BID ADDENDUM NO. (1)

Hammondsport Central School District

2025 Capital Improvements Project

1925-014

1 BATHROOM TRENCHING DEMOLITION PLAN
1/8" = 1'-0"

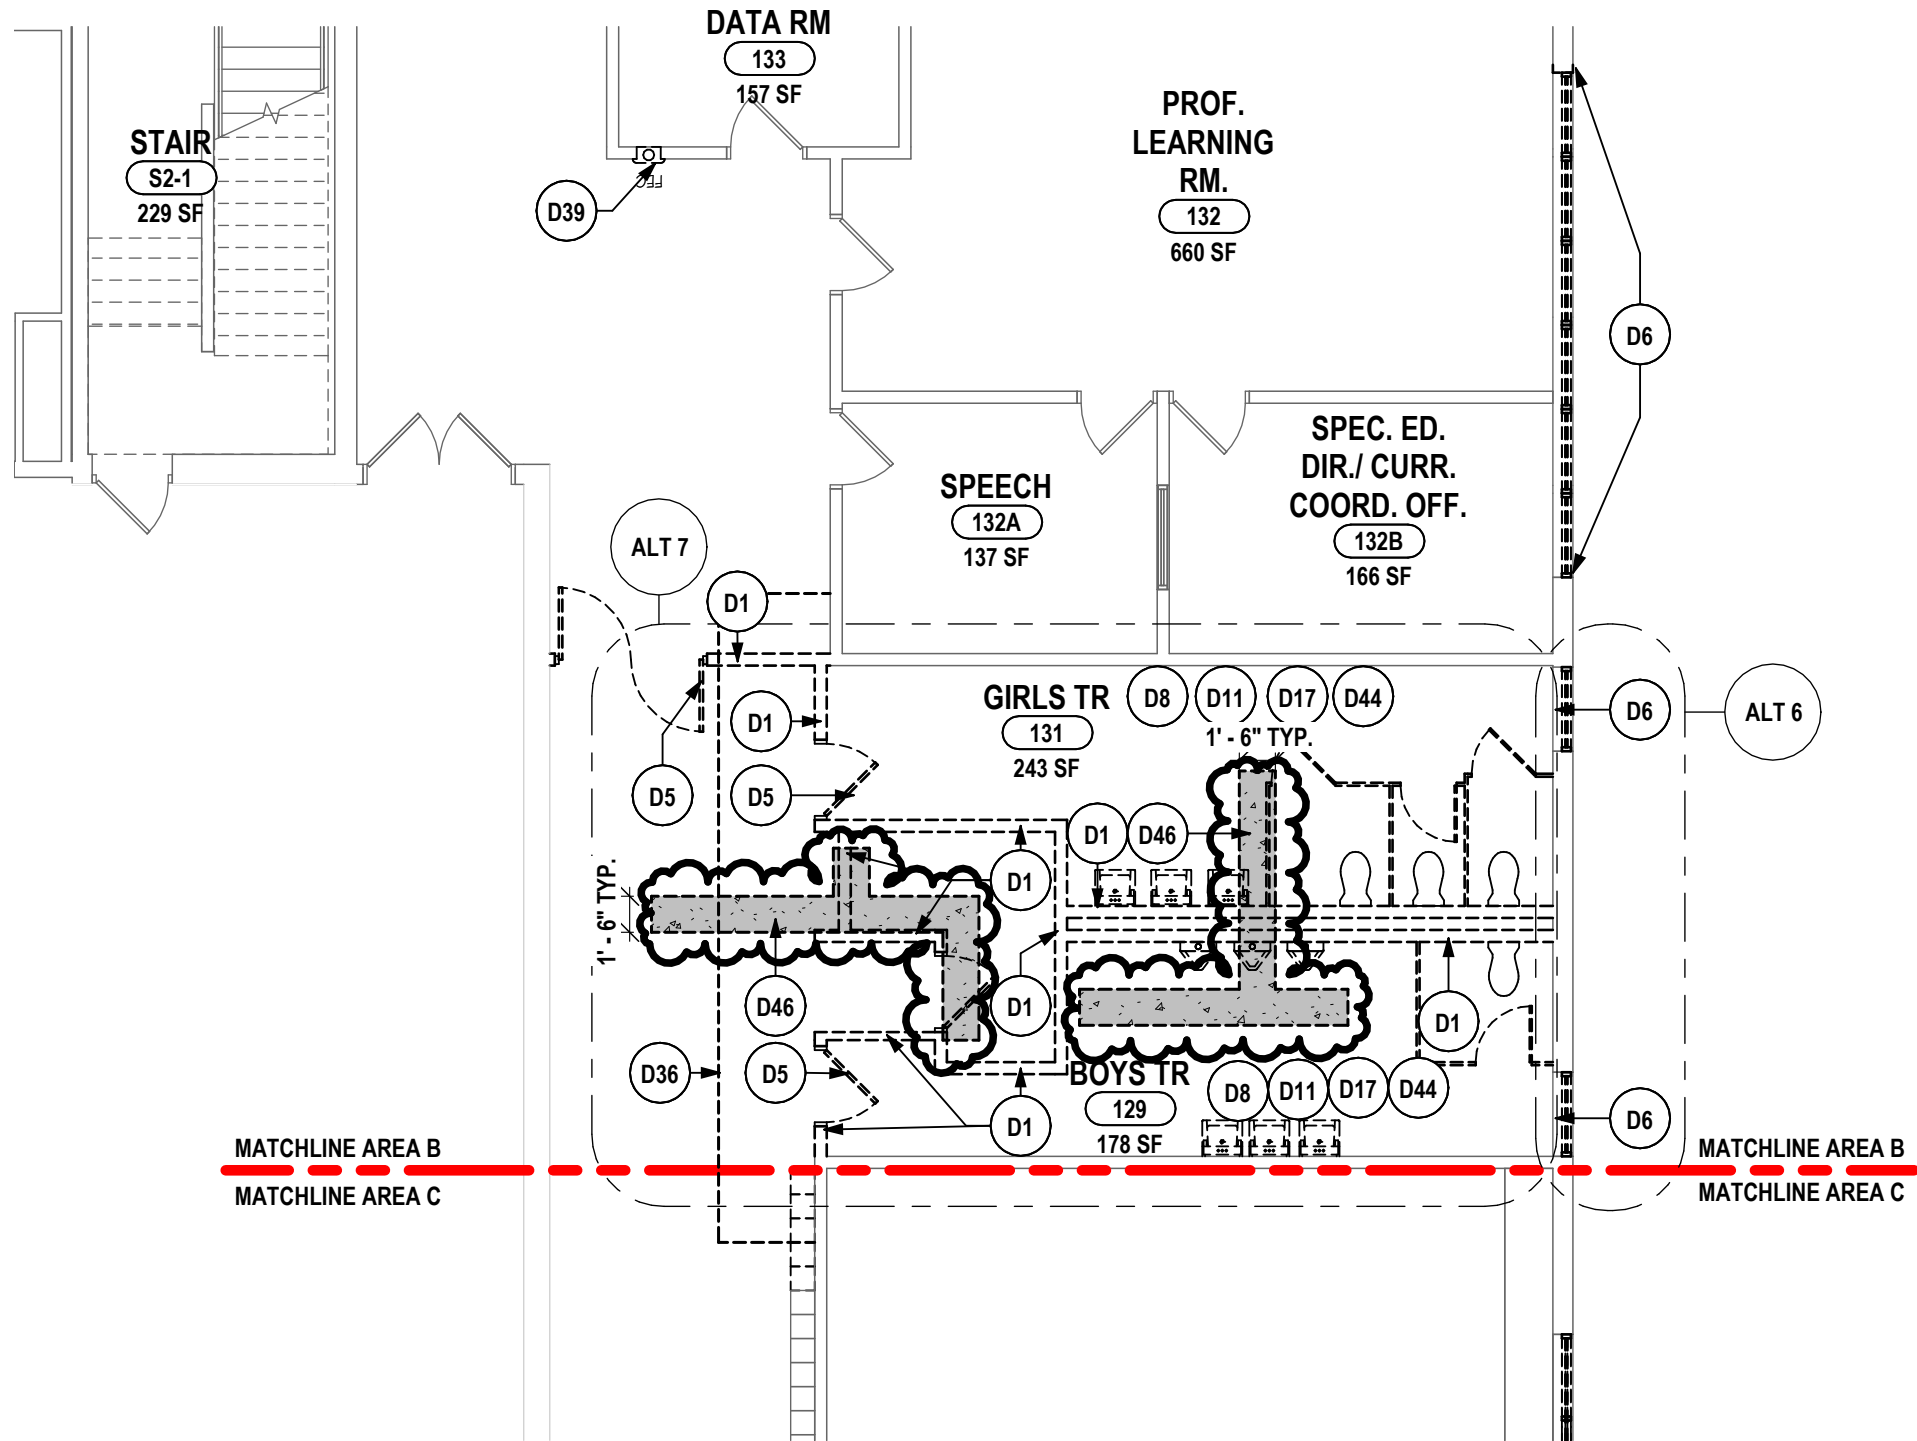
ITEM AD1-3 Refer to Drawing MB-A0.2 – FIRST FLOOR DEMO PLAN – AREA B

AMEND Detail 1, as shown on drawing AD1-A1 – BATHROOM TRENCHING DEMOLITION PLAN, as issued with this addendum.
